## **Non-Concurrence Process Record for NCP-2012-009**

NCP TRACKING NUMBER  
NCP-2012-009

TITLE OF SUBJECT DOCUMENT  
ENDORSEMENT OF ELECTRIC POWER RESEARCH INSTITUTE FINAL DRAFT REPORT 10252

This non-concurrence statement pertains to NRC's impending endorsement of the final draft of 'Evaluation Guidance: Screening, Prioritization and Implementation Details (SPID)' document (ML12333A170). The SPID guidance is authored by EPRI in collaboration with NRC staff, NEI, and other industry representatives. It establishes procedures to be followed by the licensees in response to Enclosure 1 of the March 12, 2012, information request issued pursuant to Title 10 of the *Code of Federal Regulations* (10 CFR), Section 50.54(f), the so-called 50.54(f) letter (ML12053A340), regarding the reassessment of seismic hazards at the operating nuclear power plants. The 50.54(f) letter states that the reevaluation and related analysis will serve to meet NRC's obligation under the Consolidated Appropriations Act, for 2012 (*Pub Law* 112-74), Section 402, which states "The Nuclear Regulatory Commission shall require reactor licensees to re-evaluate the seismic, tsunami, flooding, and other external hazar

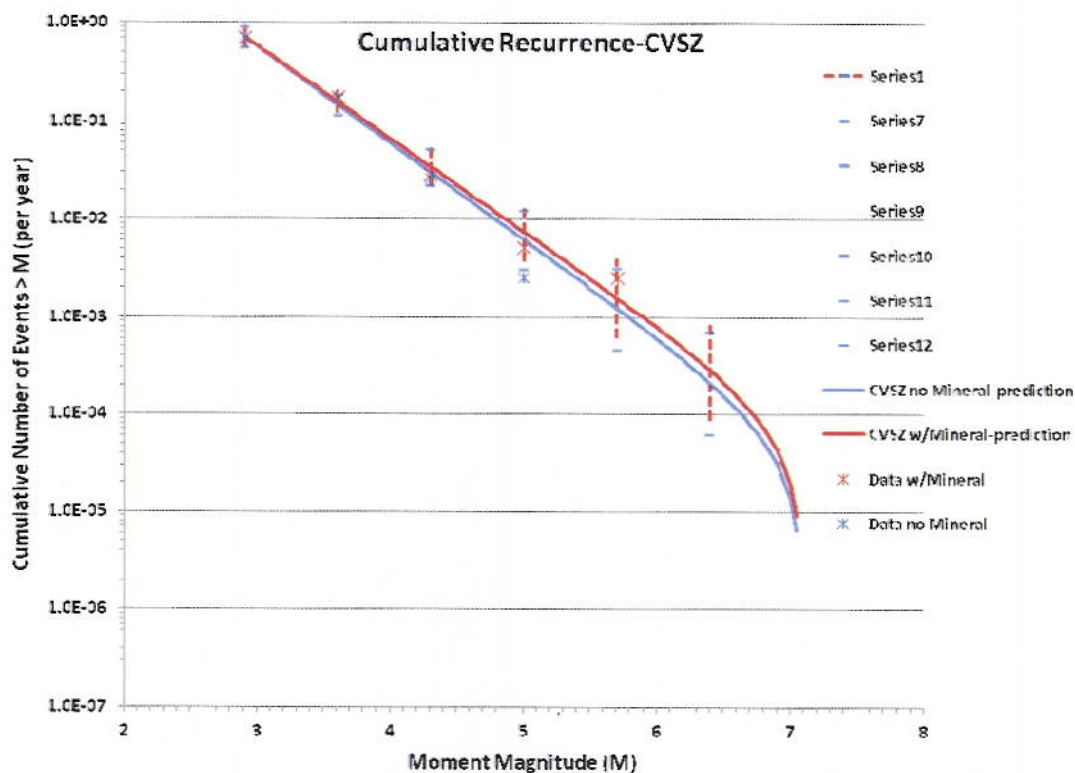
Prior to the publication of the final CEUS-SSC model earlier this year, the model developers evaluated the impact of the 2011 Mineral, Virginia earthquake and found that there would be little or no impact on any aspects of the model. The NTTF R2.1 seismic team has performed a confirmatory analysis of the Mineral, VA earthquake and determined that inclusion of this event in the CEUS-SSC earthquake catalog will not result in significant changes to the seismic hazard model. Figure 1 shows that the recurrence rates for the Central Virginia Seismic Zone both with (red line) and without (blue line) the Mineral, Virginia earthquake differ only slightly. In addition, Table 7.4.2-1 of the CEUS-SSC report (NUREG-2115) indicates that the lower bound of the maximum magnitude distribution for the ECC-AM (Extended Continental Crust – Atlantic Margin) source zone, which covers the Mineral, VA earthquake, starts at M6 and ends at M8, which exceed the magnitude of the Mineral earthquake. Hence, the occurrence of the Mineral earthquake does not challenge the existing maximum magnitude distribution for this source zone.

Figure 7.4.2-8  
Mmax distributions for the MidC-B seismotectonic zone

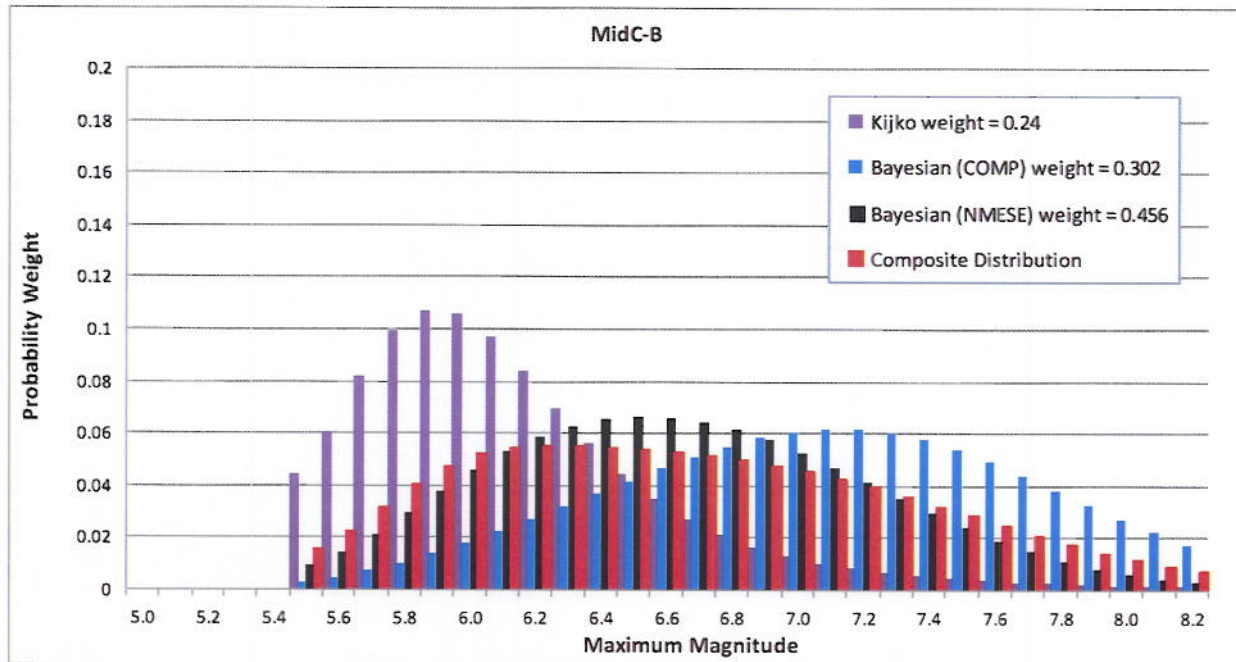
Similarly, Table 7.4.2-1 and Figure 7.4.2-8 from NUREG-2115 (included below), illustrate that the magnitude of the November 11, 2011 M5.6 Oklahoma event is equal to the lower bound of the maximum magnitude distribution (M5.6 to M8.0) for the Mid C-B (Mid-Continent-Geometry B) seismic source zone that is implemented in the hazard calculations. Table 7.4.2-1 illustrates two additional points. First, any change to the underlying distributions to incorporate the occurrence of the M 5.6 event will impact only the lower bound portion of the final distribution. Second, in the current implementation of the model, this lower bin is given the same weight as a M8 on the upper bound. Hence the maximum magnitude range for the Mid C-B seismic zone covers the M5.6 Oklahoma earthquake.

Figure 7.4.2-8 (NUREG-2115). Maximum magnitude distribution for the CEUS-SSC MidC-B seismic source zone. The 2011 M5.6 Oklahoma earthquake occurred within the Mid-B source zone. M5.6 is at the lower end of the composite distribution.

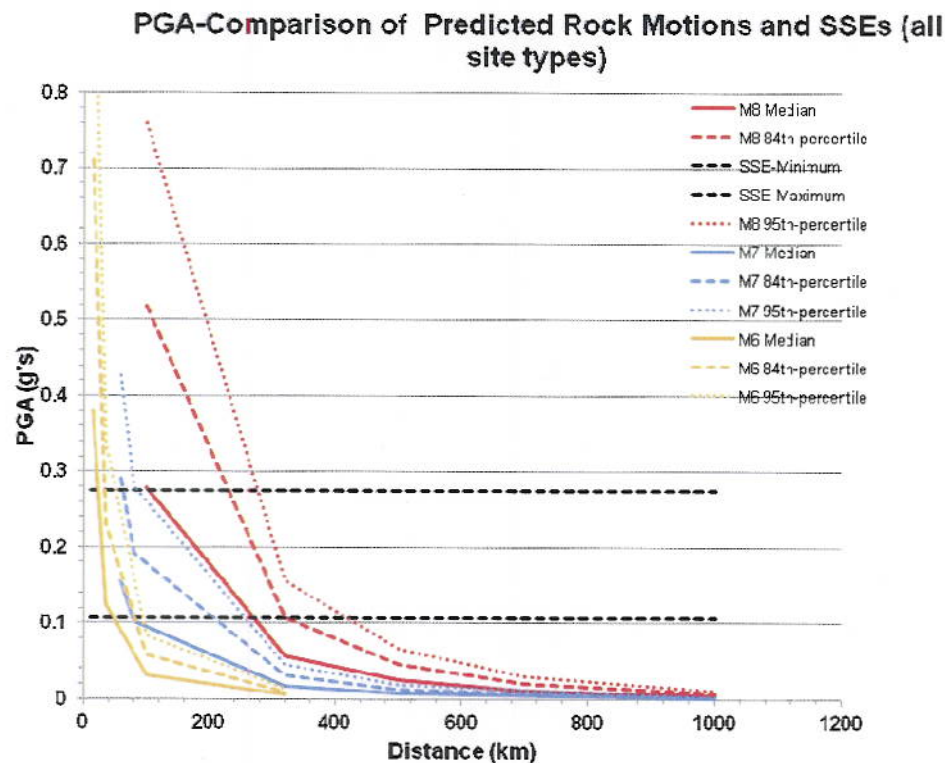
At very large distances, earthquake ground motions for even very large magnitude events are very low. [Figure 2](#) shows the peak ground acceleration (PGA) versus distance for earthquake magnitudes ranging from 6 to 8. Accelerations for each of the magnitudes are very low (about 0.1g) beyond 200 km. The black dashed line at 0.1g in [Figure 2](#) represents the minimum PGA for which all plants have to be designed even if the estimated PGA for the site is lower. Therefore, as shown in [Figure 2](#), the minimum required PGA of 0.1g is significantly greater than the estimated peak accelerations from distant seismic sources beyond 400 km. Going beyond to a distance of 1000 km, the estimated peak accelerations even from M8 earthquakes approach zero. Even at the low probabilities used to determine the GMRS ( $10^{-4}/\text{yr}$  to  $10^{-5}/\text{yr}$ ) ground motions at such large distances are negligible.

Figure 3. Comparison of shear-wave velocity profiles developed independently utilizing only the information in the Hope Creek FSAR (blue curves representing lower range, median, and upper range) with the single velocity profile used in the PSEG ESP site response analyses.

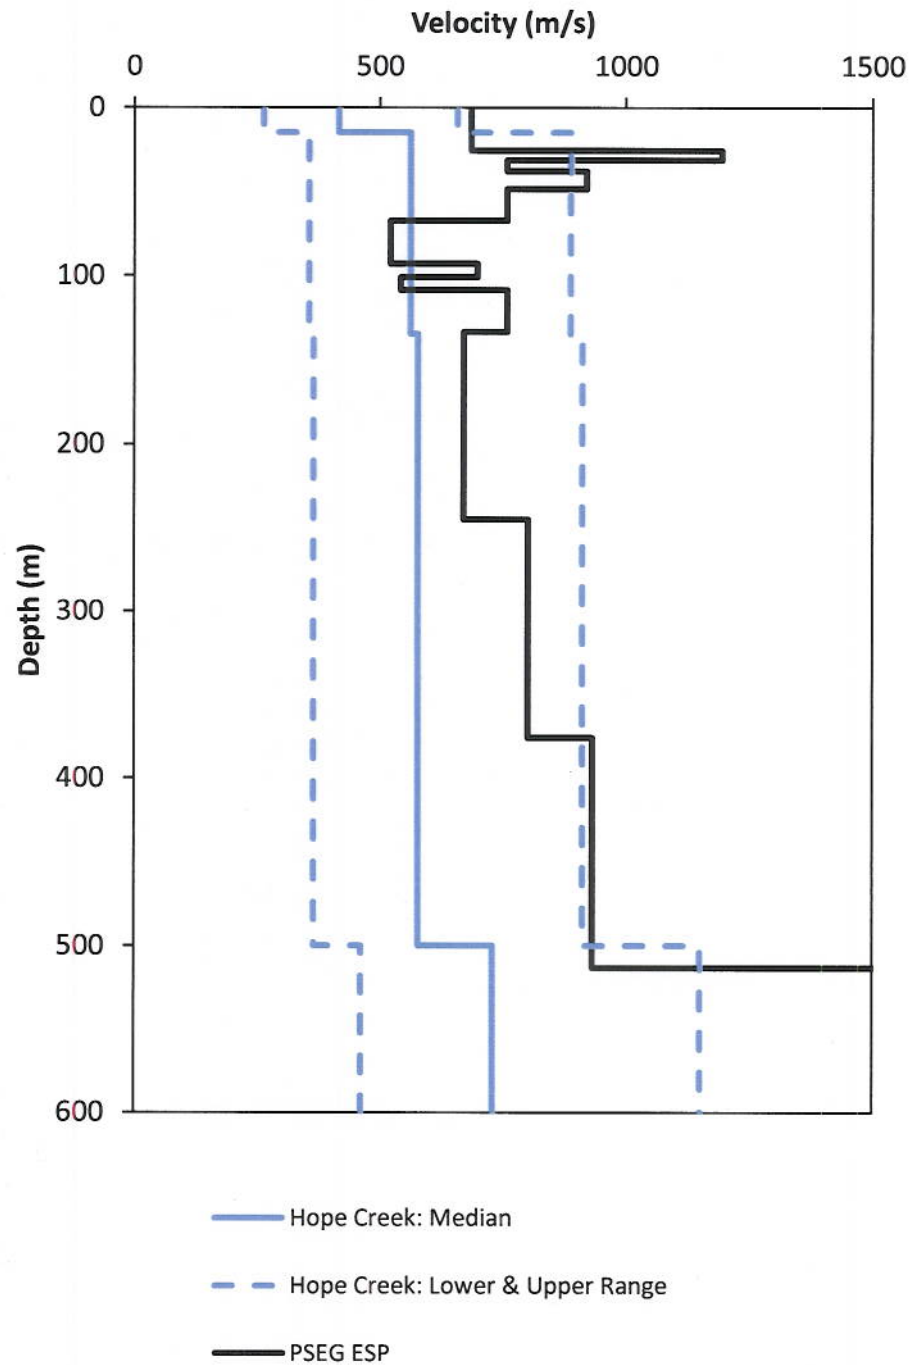
To exercise and evaluate the site response approach in the SPID, NRC staff performed a case study at an operating plant located next to an ESP site. The NTTF R2.1 Seismic Team

developed a geologic profile for the operating site based on the information and data in the FSAR using the approach in the SPID. This result was then compared with the modern data acquired by the ESP applicant for the adjacent site. Figure 3 shows that this ESP profile reasonably matches and falls within the three base estimates of the profile developed using the FSAR data and the SPID approach. Figure 4 shows that the application of the site response approach described in the SPID using the geologic information from the operating plant FSAR closely matches the results from the co-located ESP, which is based on direct geophysical measurements of the subsurface. What is important to note in Figure 4 is the comparison between 1 to 10 Hz. Determination of whether a plant SSE has been exceeded and additional plant risk evaluations are needed or not is based on comparing the SSE and GMRS in this frequency range. This is the important frequency range for many of the nuclear power plant structures, systems, and components. This comparison further shows that in a probabilistic analysis, due to randomization and multiple analyses, seemingly large variations in profiles and properties are much less important in the aggregated results, such as the mean amplification factors shown in Figure 4.

**Figure 2.5.10.** Combined Plot of Fractile S-Wave Models for SASW and Checkshot Surveys the Saddle Mountains Basalt. Also shown is the DC-1 inferred model for two hypothetical values of  $V_p/V_s$ .

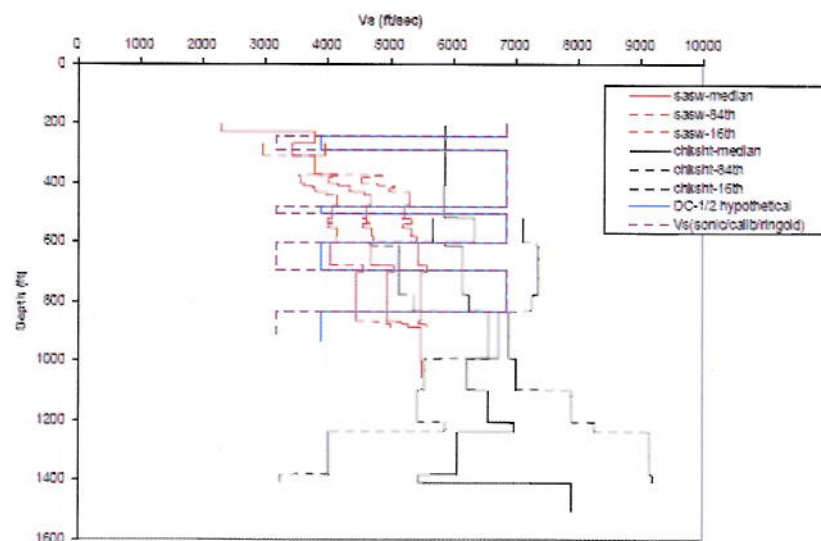
The figure below illustrates the level of uncertainty that often arises in the characterization of a particular site. It shows the measured shear-wave velocity profiles measured at a DOE site. These data were acquired recently using modern techniques. Based on the number of detailed investigations performed, this would be described as a "well-characterized" site. It is clear that

the predicted velocity profiles are subject to considerable uncertainty associated with the method used to measure in-situ shear-wave velocity. This uncertainty will vary with the characteristics of the site and the type of measurement technique being used. It is not accurate or appropriate to infer that even well-characterized sites have no uncertainty associated with the site profiles. This uncertainty in the estimates of shear-wave velocity results in uncertainty in the site response.

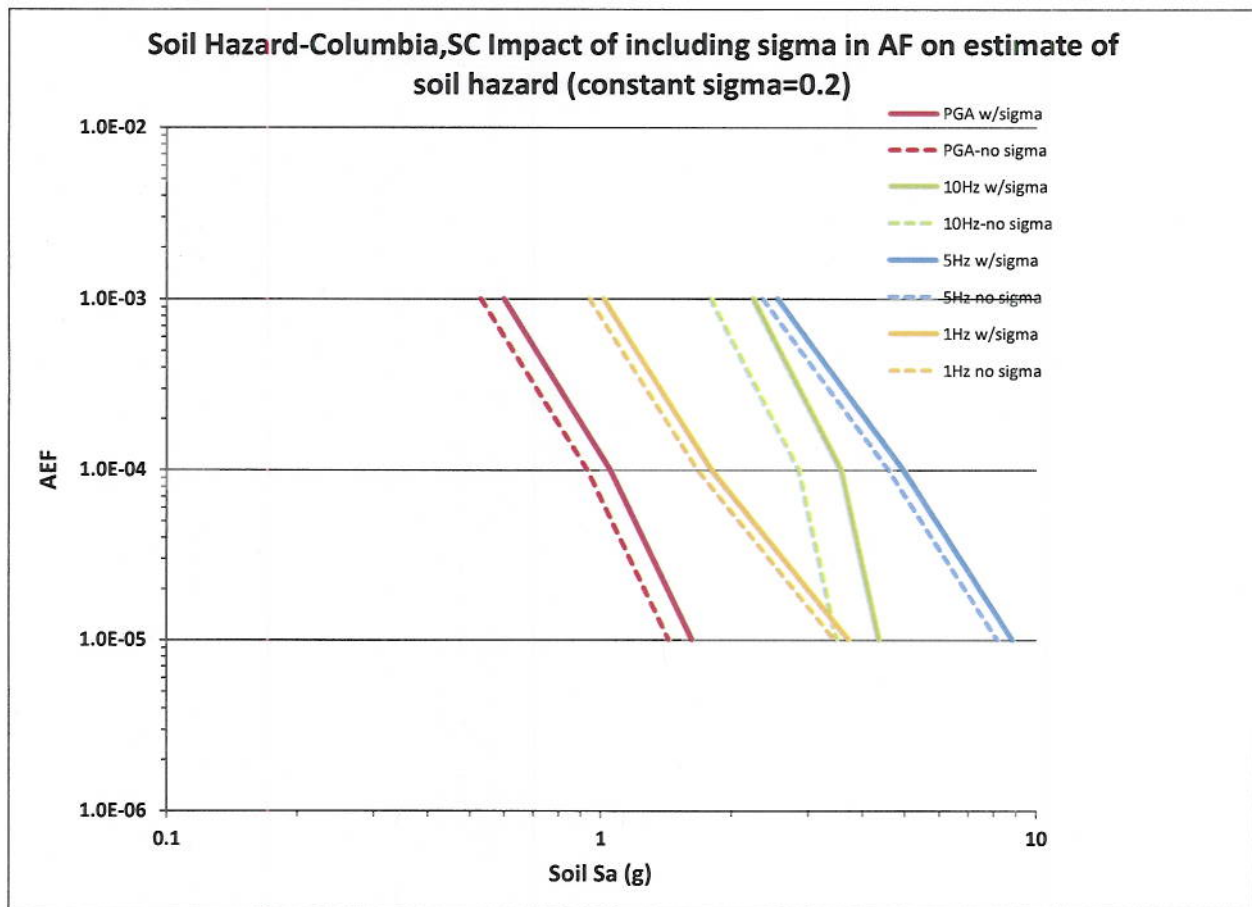
The approach currently utilized in the development of the GMRS for COL/ESPs utilizes a mean estimate of the site-specific amplification function for those sites not located on hard rock. The approach described in the SPID explicitly incorporates the full uncertainty distribution in the calculation of the soil hazard. This approach is conservative relative to the approach utilized in the COL/ESPs. An example of this effect is shown in the Figures 5 and 6 below.

The NRC NTTF Seismic staff concludes that the approach outlined in the SPID realistically evaluates the impact of uncertainty in site and material properties on estimates of the site-specific seismic hazard. Increased uncertainty in the site amplification function results in conservative estimates of the seismic hazards relative to approaches that do not explicitly incorporate this uncertainty. The effect of increased uncertainty in the site amplification functions on the computed soil hazard is illustrated in the figure below. Using this approach, the NTTF R2.1 Seismic Team believes that a reasonable estimate of the site-specific hazard for most sites can be determined. The estimate of the GMRS derived from the site-specific seismic hazard is used to determine if further risk evaluations of the nuclear power plant in the form of a seismic PRA or seismic margins analysis is warranted.
